Access Compliance Report

Public Rights-of-Way

(Curb Ramps)

Intersection ID: 13871	Main Street: E_5TH_ST	Cross Street: HAWTHORNE_LN	Location: SW
ADA ID: 9A98359CC72C	Ramp Type: Perp	Initial Pass/Fail: Pass	Overall Compliance: No
Severity Score: 0			
Codes/Mitigation Info/Possible Solution		Field Measurements/Component Compliance

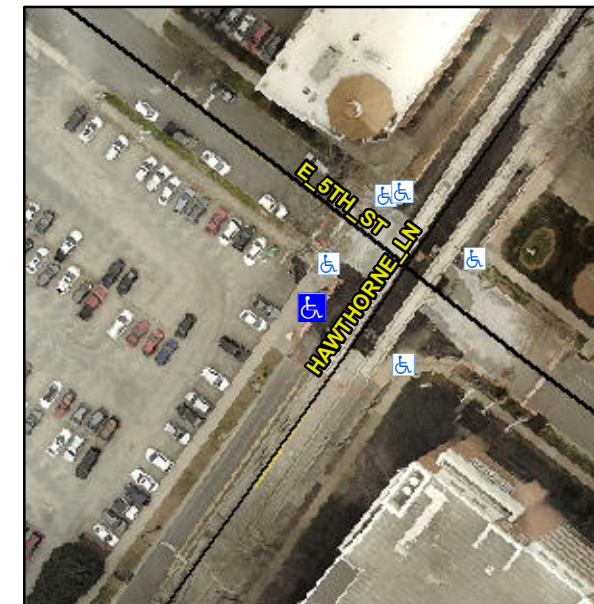
Remove & Replace Landing. Gutter Ponding Observed.

R304.2.1, R304.2.2-Perp, R304.3.2-Para, R302.7
